# Farseeing Knit Composite Ltd

# Observations

# **Lateral stability system unclear in Main Production Building**

Main Production & Office Building

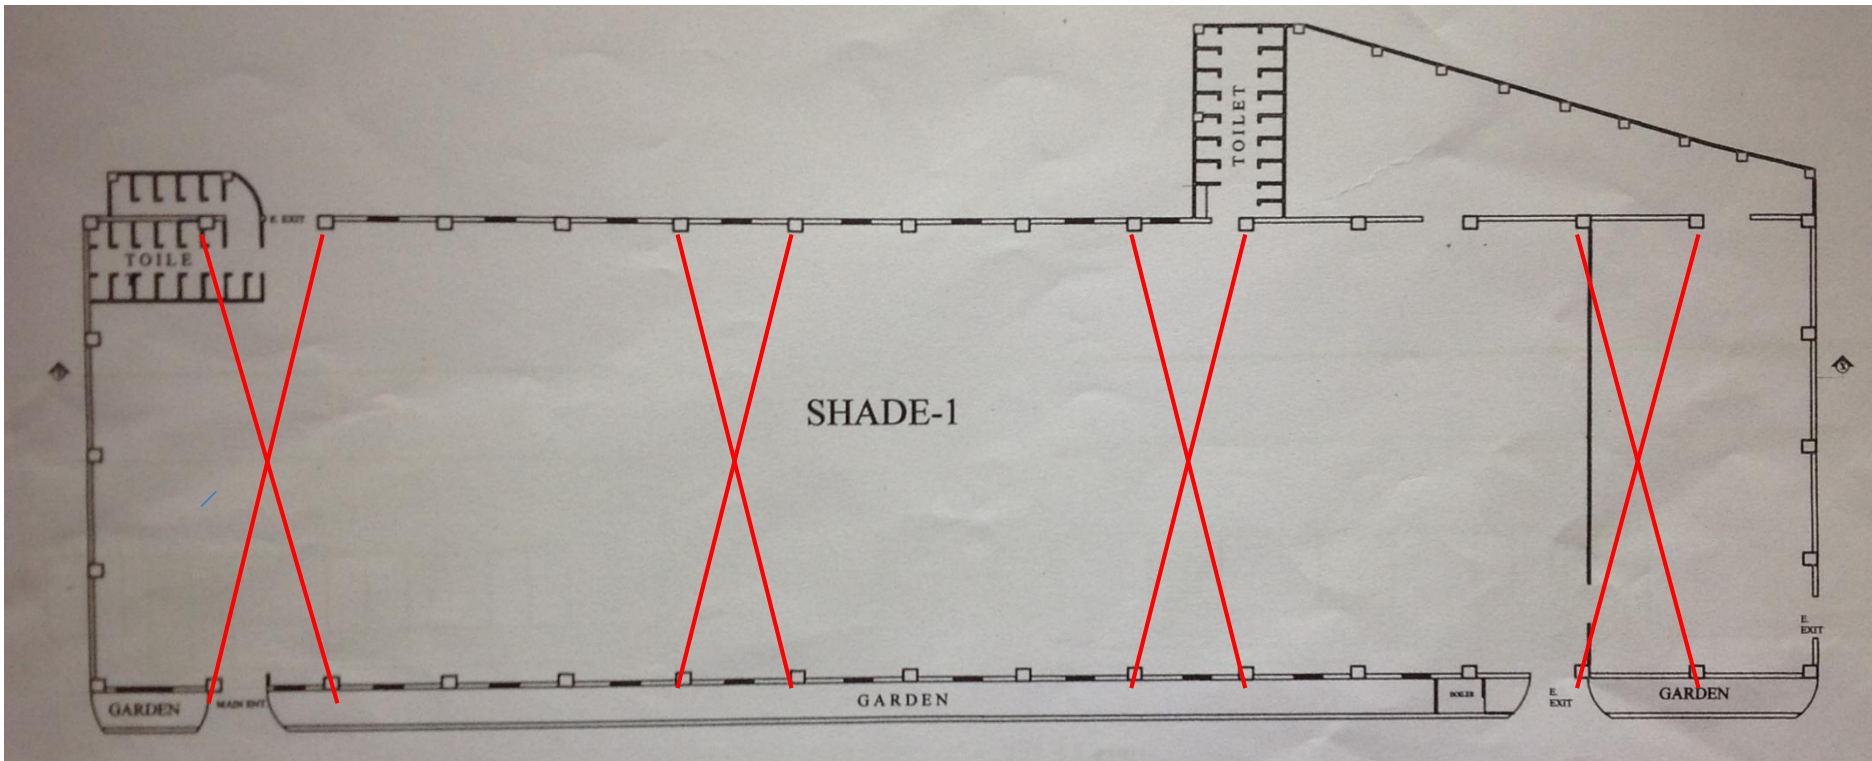
The lateral stability system to the Main Production structural steel shed is unclear – vertical bracing and eaves beams have not been provided. Note that provision for lateral stability is not shown in the as-built drawings. Building Engineer to carry out a lateral stability analysis of the shed and specify the necessary remedial works. Furthermore, Building Engineer to review the design of the cantilevered columns to ensure they can adequately resist the horizontal loads imposed by the portal frame.

Vertical bracing system missing to Main Building

Bracing connection detail for horizontal bracing is provided to stanchion but not used. Eaves beam missing.

Only Horizontal Bracing provided to Main Building

Eaves beams missing to Main Production Building

Pin connection between portal frame and cantilevering RC columns – The horizontal force transferred into the top of the columns will need to be transferred into the foundation through cantilever action

Building Engineer to review the design of the portal frame with regard to lateral stability. The Building Engineer should provide guidance on the requirement or otherwise for vertical bracing and eaves beams in the external wall to enable the horizontal wind loads to be transferred down to foundation level. Furthermore the Building Engineer is to review the design of the cantilevered concrete columns to ensure that they are adequate to resist the horizontal loads imposed by the steel portal frame.

Carry out any remedial works as determined by the Building Engineer

Main Production / Office Building Layout Plan

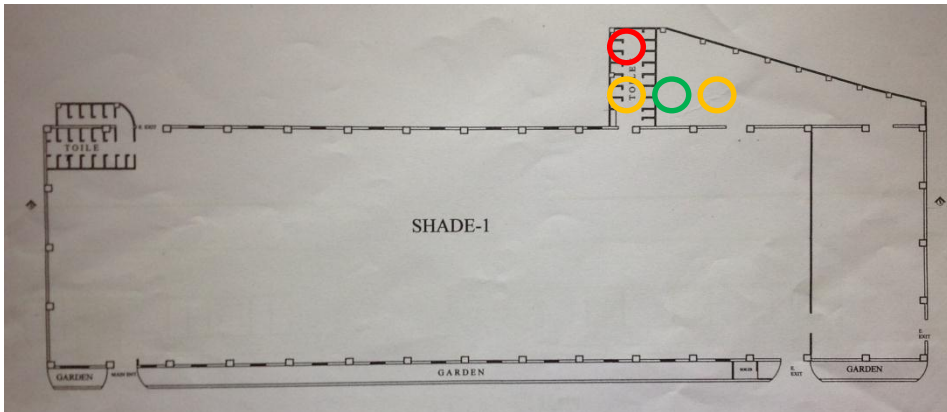
An area of high loading was observed above the toilet area to the South of the main Production / Office building where there are four plastic water tanks located at Roof level. There is one 5000L capacity tank on a 160mm plinth, two 2000L capacity tanks on 900mm plinths, and one 2000L capacity tank that is damaged and appears to be out of use. Building Engineer to check that the roof structure has been adequately designed to accommodate this loading.

5000L water tank on 160mm plinth at Roof level

2000L water tanks on 900mm plinths at Roof level

Damaged 2000L water tank on damaged plinth at Roof Level

Building Engineer to be appointed to review the design of the roof slab over the male toilets to ensure that the structure as-built is adequate to carry the applied loads. Carry out strengthening works if required.
